**TECHNICAL BULLETIN**

## TECHNICAL BULLETIN #128

**SUBJECT:** Torque Specifications for SCBA Cylinders and Valve Assemblies

**PRODUCTS AFFECTED:** Survivair® SCBA Cylinder Valves, Part Numbers 921040, 921045, 961165, 921065, 920312, 920322, and 964833 only.

FIG 1

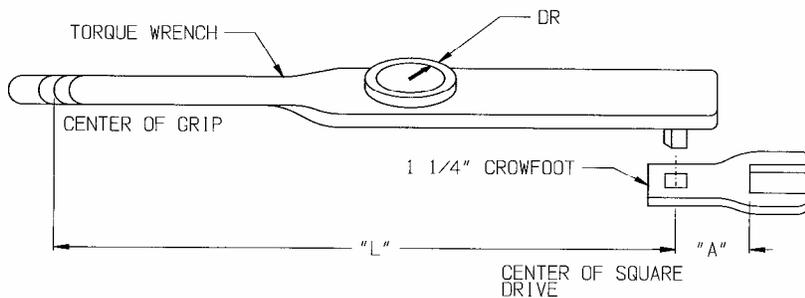
Torque Correction Factor: using a Crowfoot or any extension on a torque wrench alters the true torque from the direct dial reading. The following procedure will determine the correction factor, CF, for your particular toque wrench with the addition of a 1 1/4" crowfoot. Refer to FIGURE 1

**L** = the handle length generally measured form the center of the square drive to center of the handle grip. Refer to your torque wrench manual for the specific length.

**A** = the distance between the bottom of the crowfoot throat to the centerline of the square drive.

**DR** = the direct reading or the dial on the torque wrench  
**.625** = the distance from the crowfoot throat to the center of the cylinder valve body.  
**CF** = correction factor to convert dial reading to actual torque  
**AT** = actual torque

$$\mathbf{CF = (L + A + .625) / L}$$

$$\mathbf{AT = (DR)(CF)}$$

The maximum permissible breakaway torque limit (actual torque, or AT) is 80 ft-lb. The maximum breakaway direct reading that corresponds to 80 ft-lb can be calculated by dividing 80 by the CF:

$$\mathbf{\underline{MBDR=(80)/(CF)}}$$
